IDAP REPORT

Property:	55 Arthur Street STRATHFIELD DA2020/208 Demolition of the existing dwelling and ancillary structures and construction of a two (2) storey dwelling with a basement level and in-ground swimming pool.
Proposal:	
Applicant:	Urban Link Pty Ltd
Owner:	A. Al-Jaradat
Date of lodgement:	4 December 2020
Notification period:	18 December 2020 to 25 January 2021
Submissions received:	One (1)
Assessment officer:	N Doughty
Estimated cost of works:	\$1,550,000
Zoning:	R2-Low Density Residential - SLEP 2012
Heritage:	No
Flood affected:	No
Is a Clause 4.6 Variation Proposed:	No
RECOMMENDATION OF OFFICER:	APPROVAL

Figure 7: Shadow diagrams of proposed development and adjoining properties at the winter solstice.

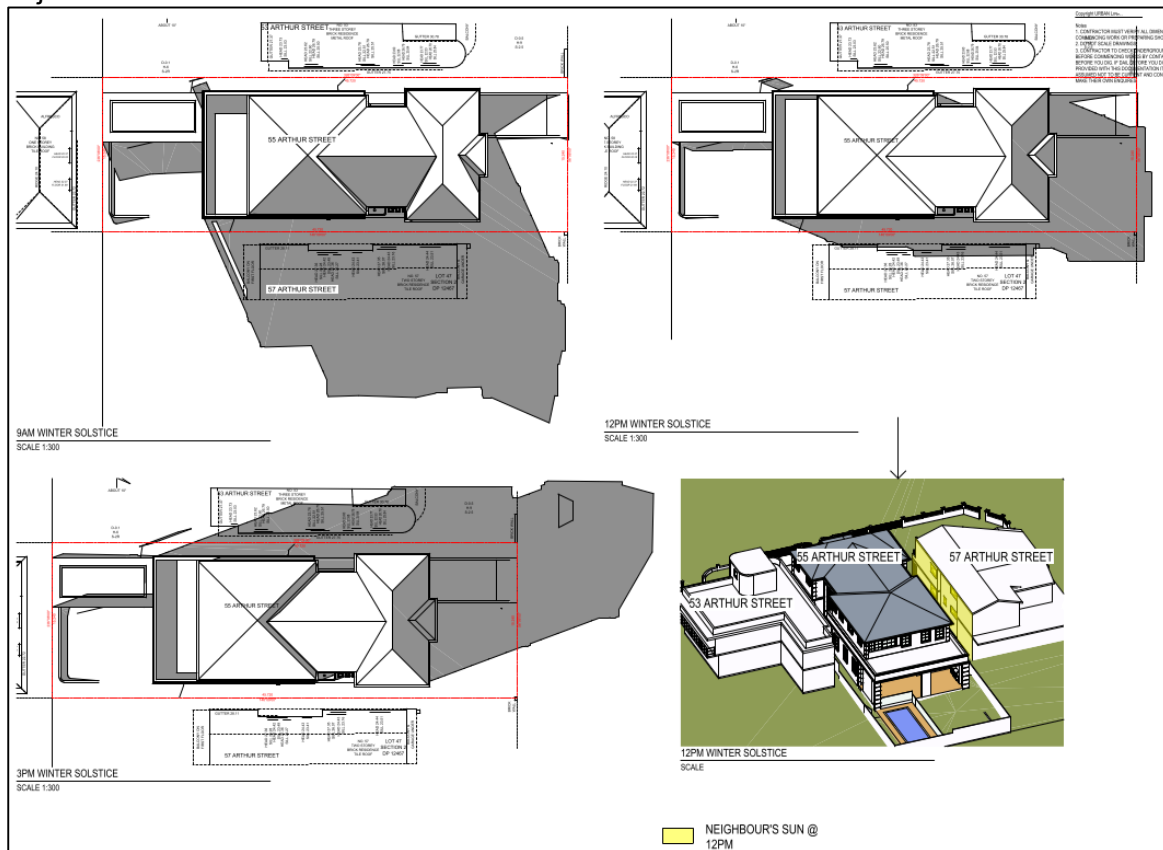
The dwelling is oriented to the south, enabling solar access to windows of habitable rooms and the private open space for a minimum period of 3 hours between 9:00am -3:00pm at the winter solstice. The north-south orientation of the site results in unavoidable overshadowing onto the adjoining southern dwelling. Solar access to windows of high use rooms and the private open space is achieved for a minimum period of 3 hours between 9.00am-3:00pm at

the winter solstice (Figure 7). The proposal is considered to generally satisfy the relevant objectives and controls of the SCDP 2005.
